SUBJECT: 19EA,FA SENSORS

F.E.R. 78-4

PURPOSE: To provide a procedure for troubleshooting bearing and motor sensors.

19EA BEARING, DISCHARGE, AND MOTOR SENSORS

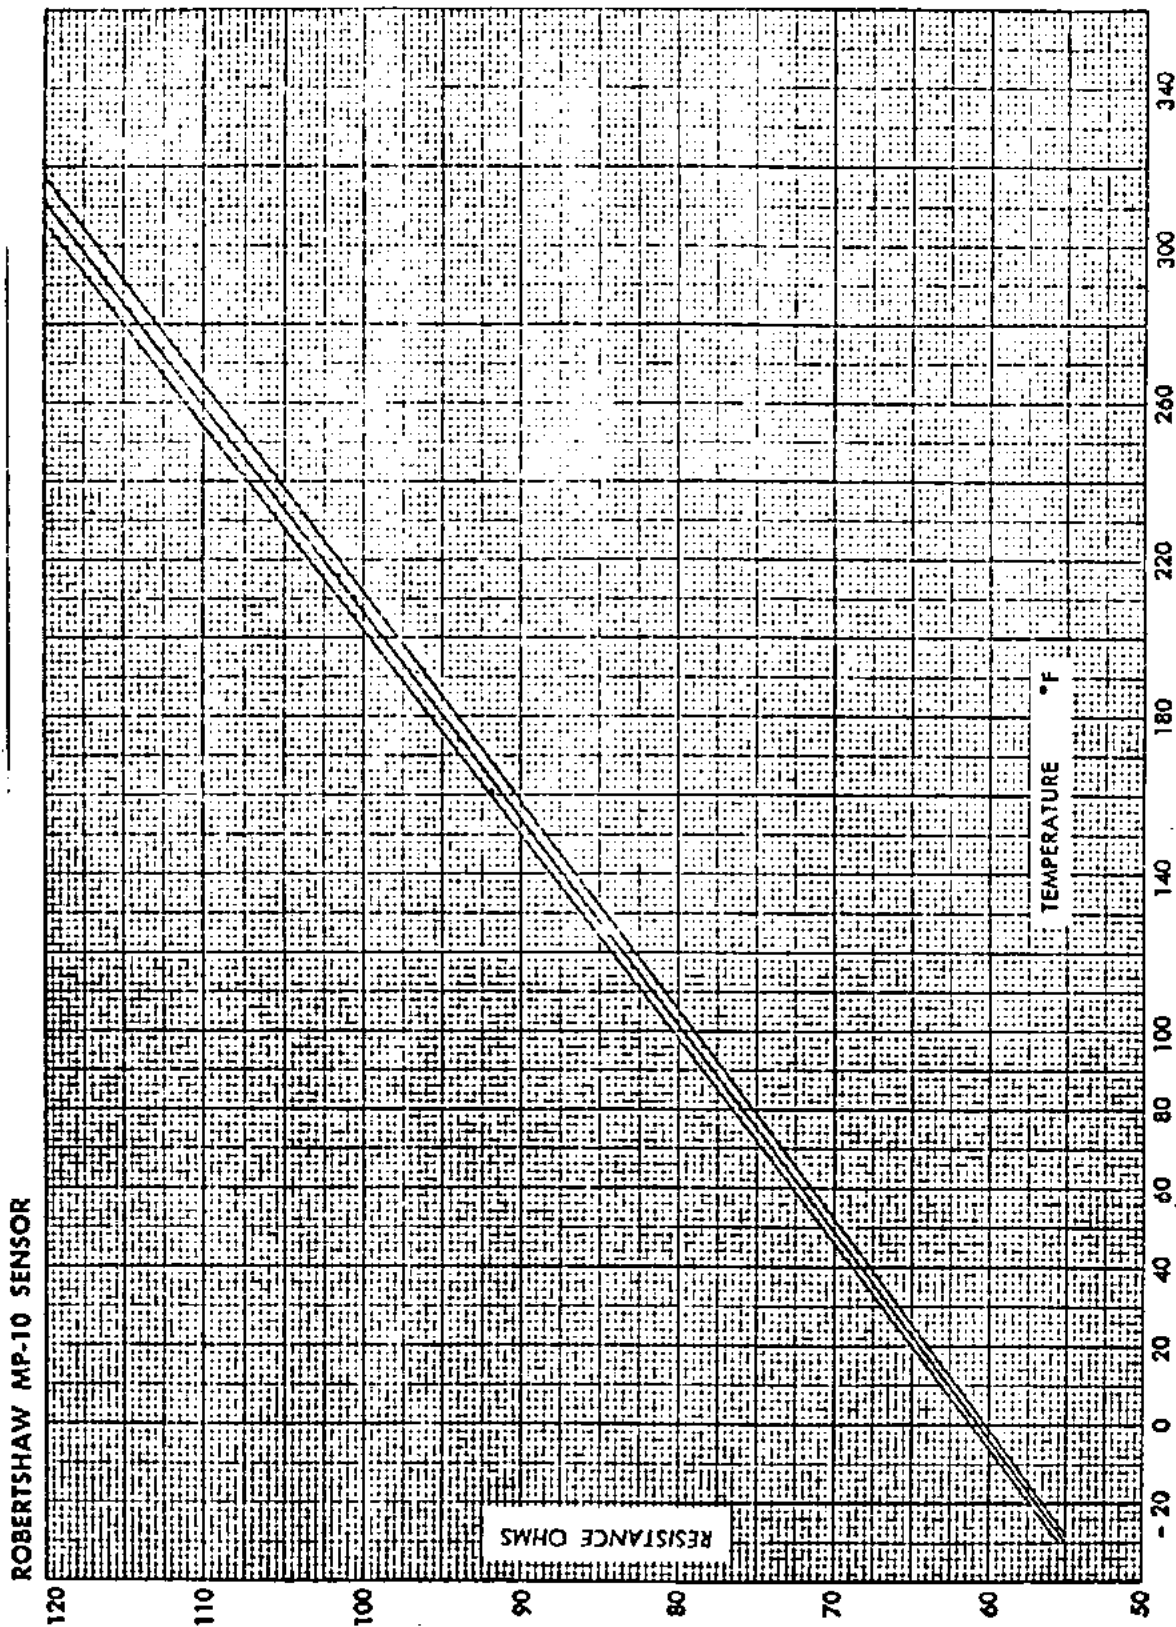
2.1.1. Defective Sensors - Check the resistance reading across the sensor. The resistance - temperature relationship shown in Sketch #1 should be evident if the sensor is functioning properly. The bearing, motor, and discharge sensors (if applicable) should be checked.

Sensor Resistance versus
Sensor Temperature (Linear).
Chart 904810
